# CITY PLANNING COMMISSION

- APPLICATION:
- A. Negative Declaration
  - B. Tentative Map to establish one air space condominium lot.
  - C. Special permit to develop 100 condominium units on 9.8 vacant acres in the Single Family Alternative (R-1A) zone.

PROPOSAL: The applicant is requesting the necessary entitlements to construct 100 unit condominium project on 9.8 acres.

ATTACHMENT A  
DISCUSSION OF INITIAL STUDY FOR FRANKLIN VILLAGE  
P88-359

END ELEVATION S  
 SCALE: 1/8" = 1'-0"

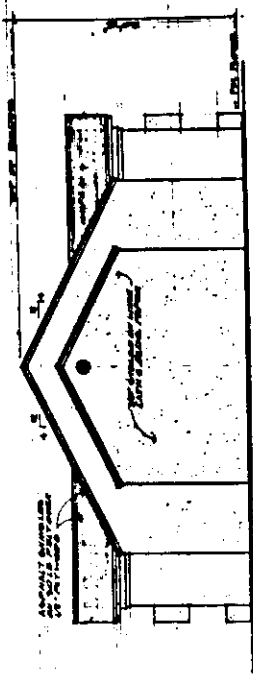
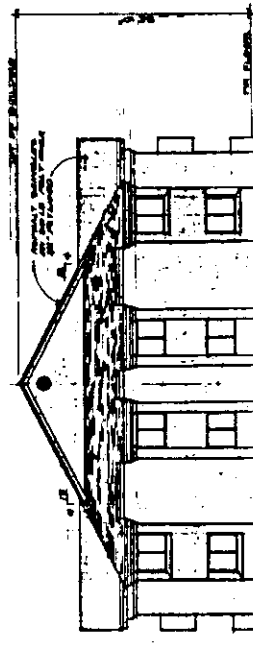
The exterior building materials for the units will include stucco/wood siding and composition shingle roofs. Staff observes that the building design provides good architectural relief on both the front and end elevations for the A and C units. The B unit end elevations shall be revised to show more relief (windows, recesses, etc.).
